Q-22-737

ADDENDUM NO. 1

FORT RITCHIE MANHOLE MONITORING

FORT RITCHIE
MONITORING MANHOLE
MANHOLE AND GRAVITY LINE
PLAN AND PROFILE

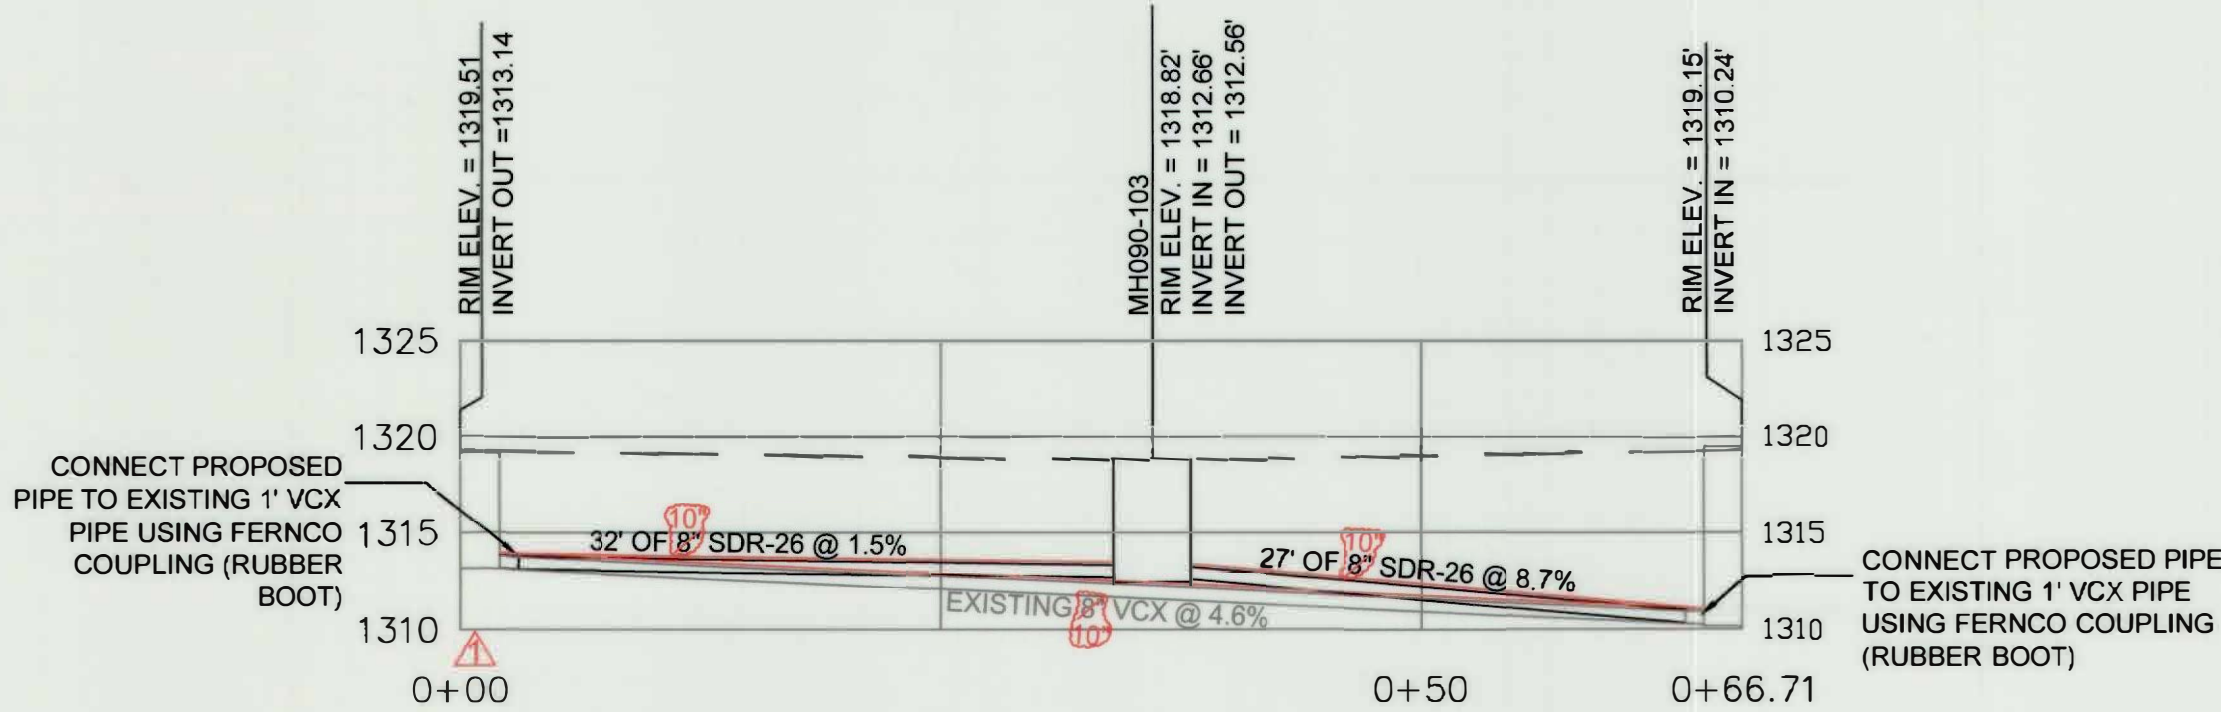
ITEM NO. 2: A **REVISED** drawing, Page 2, Manhole and Gravity Line Plan and Profile is included as an attachment to this Addendum as Attachment No. 2. The revision resulted in changing the pipe size.

ITEM	QUANTITY
48" MANHOLE WITH 30" FRAME AND COVER	1 EA
8" SDR-26 10' SDR-26	58 FT
PAVEMENT REPAIR	66 FT
INSTALLING FLOW METER IN MANHOLE	1 EA
FERNCO COULPING	2 EA
